**GENOA CHARTER TOWNSHIP  
PLANNING COMMISSION PUBLIC HEARING  
JANUARY 13, 2025  
MONDAY  
6:30 P.M.  
AGENDA**

**OPEN PUBLIC HEARING #1...** Consideration for a rezoning application, PUD agreement, environmental impact assessment, PUD conceptual and preliminary site condo plan to rezone 127.57 acres from Agriculture (AG) to Low-Density Residential (LDR) to allow for a proposed 55-unit single-family site condominium development located at the northwest corner of Challis Road and Bauer Road. The proposed rezoning is for the following parcels: 4711-23-400-008, 4711-23-400-007, 4711-23-400-001 and 4711-23-300-003. The request is submitted by Pulte Homes of Michigan.

**GENOA CHARTER TOWNSHIP  
SPECIAL PLANNING COMMISSION  
PUBLIC HEARING  
December 4, 2024**

**PARALLEL SITE PLAN**

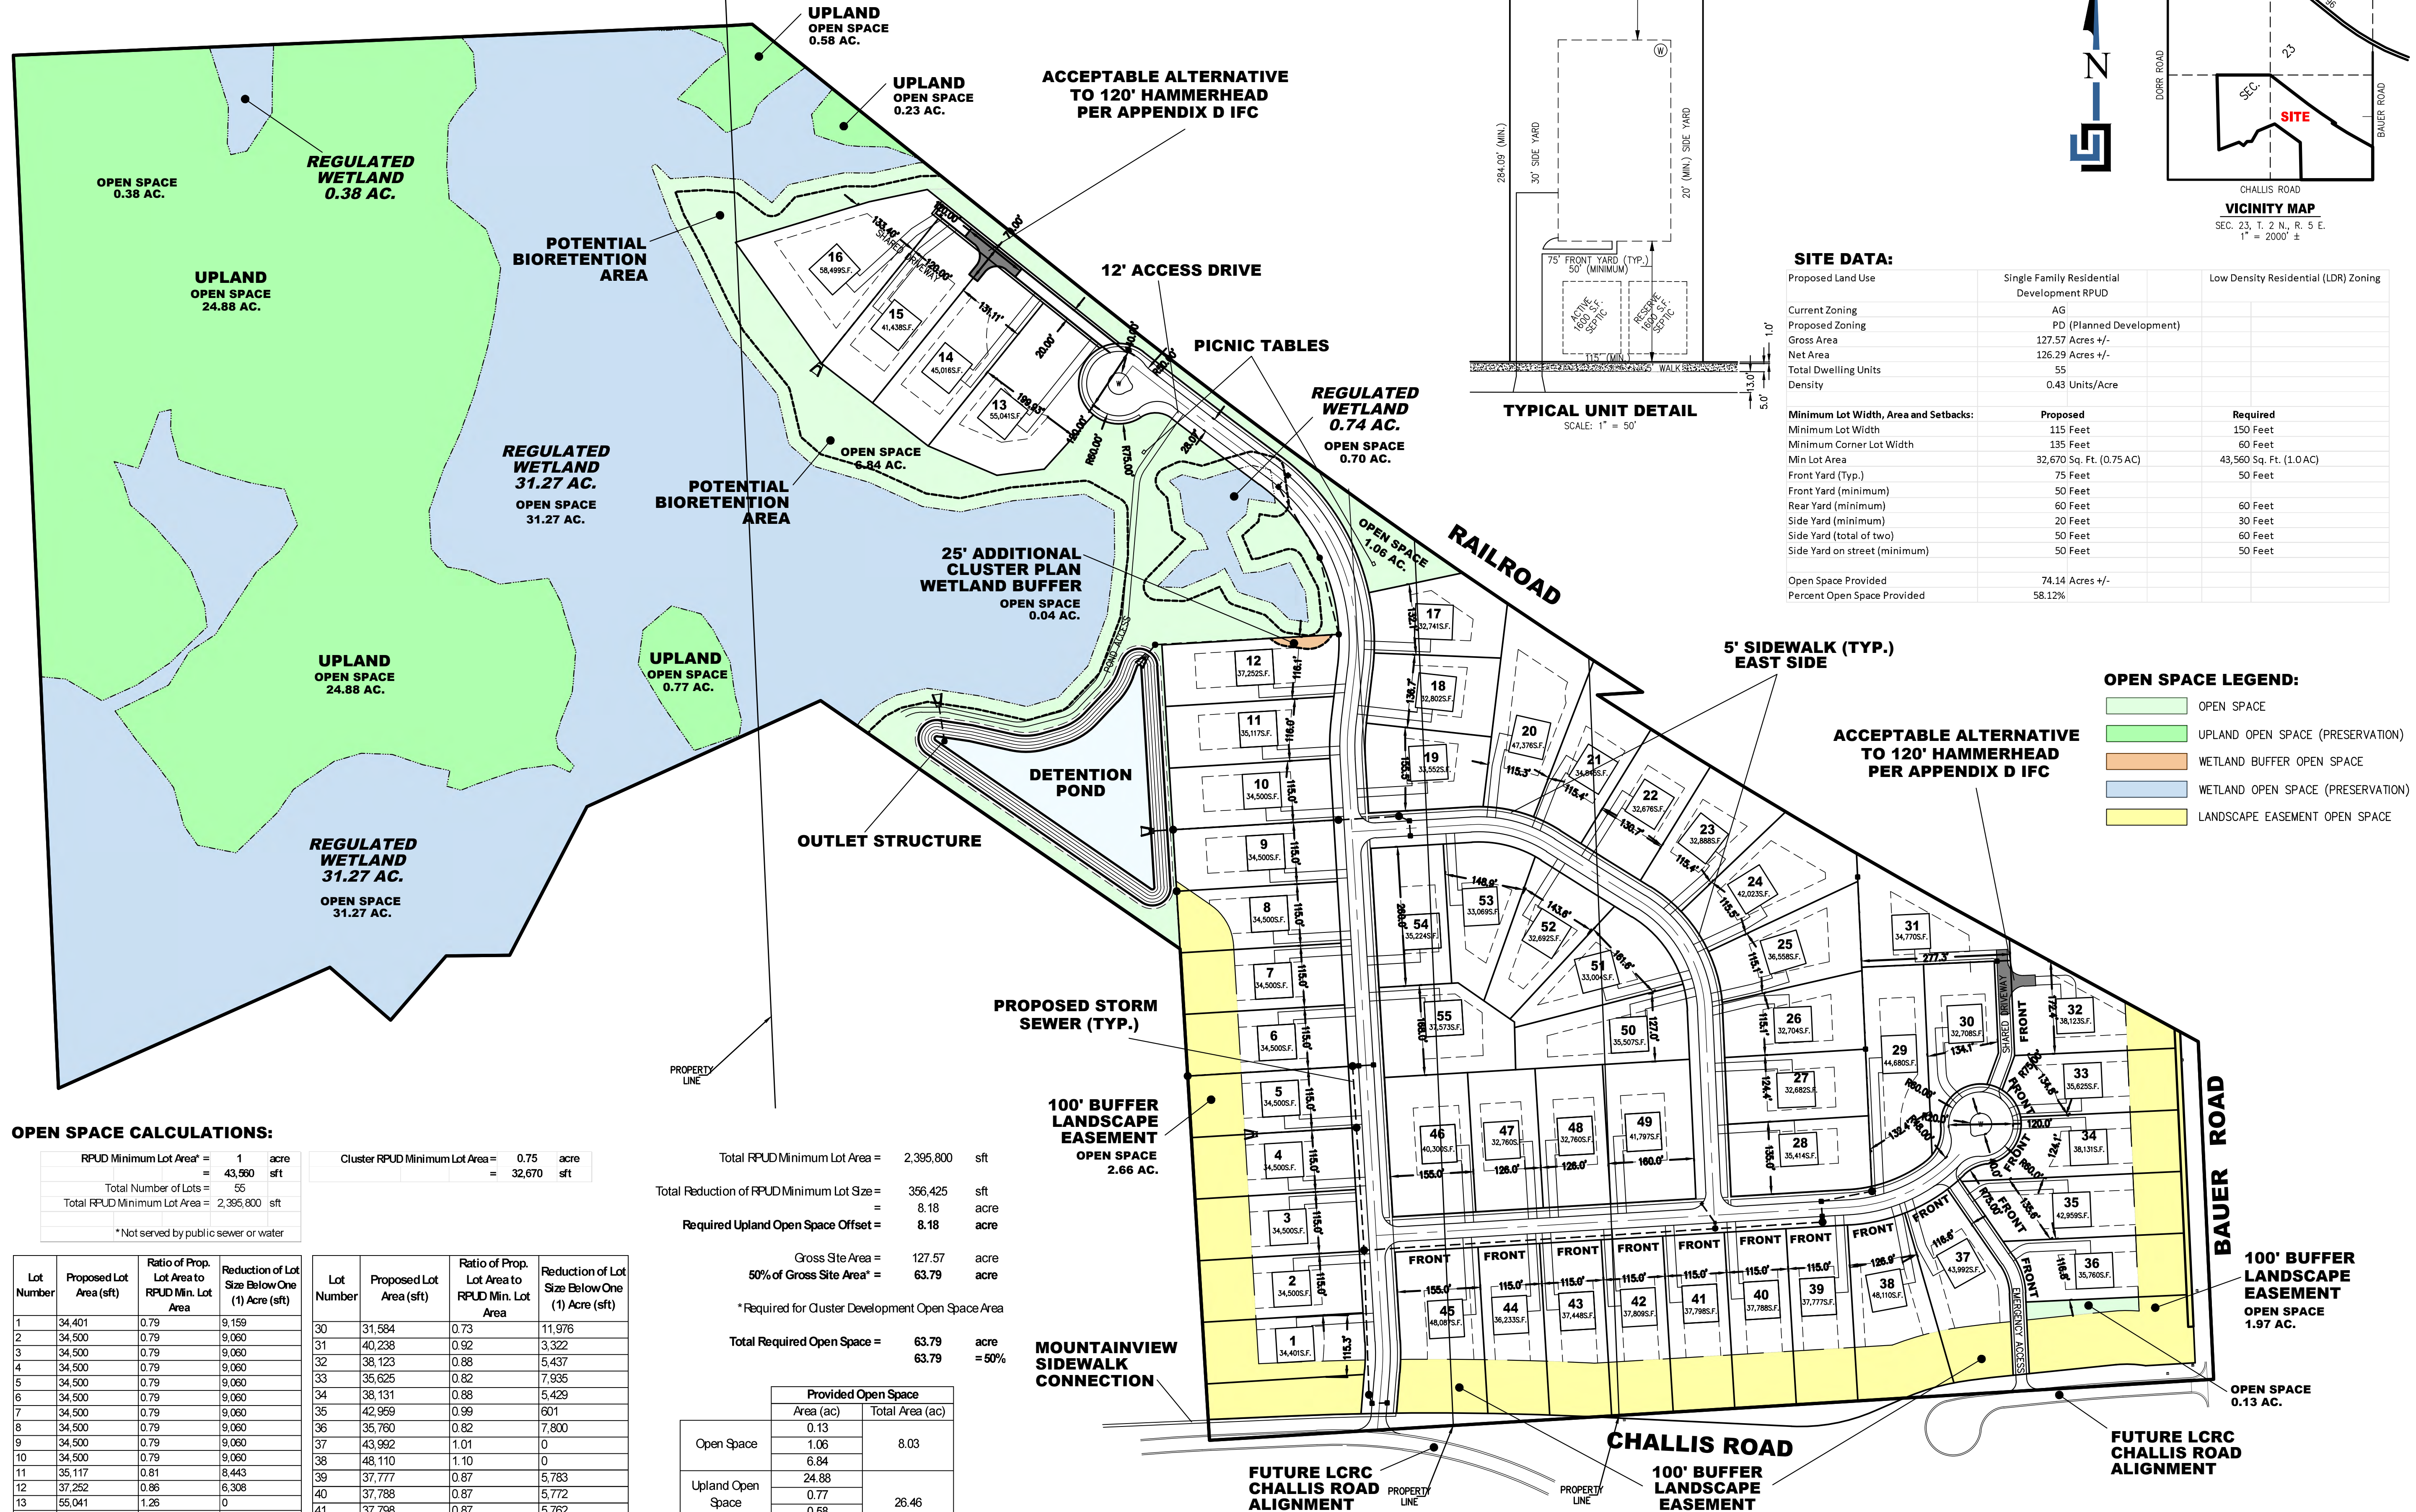
- b. The parallel plan includes a roadway that crosses two regulated wetlands, which will require approval and permits from EGLE.
  - c. The Township may wish to require sidewalks as part of the project.

CLIENT: SA/BB/MG  
 DR BY: SA/BB/MG  
 CK BY: SA/BB  
 P.M. MN  
 SCALE: 0 75 150  
 JOB NO. 231213  
 SHEET NO. **C3**  
 SHEET C3 OF 5

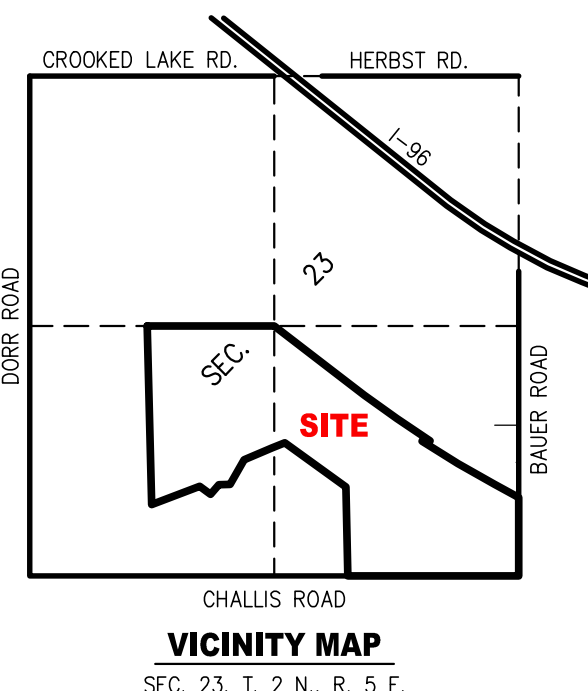
The typical unit detail on Sheet C3 depicts compliant setbacks for the front, rear and 1 side yard; however, the 2<sup>nd</sup> side yard and combination of side yards are deficient by 10 feet (20' one side and 50' combination proposed).

- 54 of the 55 units exceed the minimum allowable area of 32,670 square feet; however, Unit 30 provides only 31,584 square feet of lot area. Additionally, the table on Sheet C3 includes a typo for the area of Unit 24. These items must be corrected.
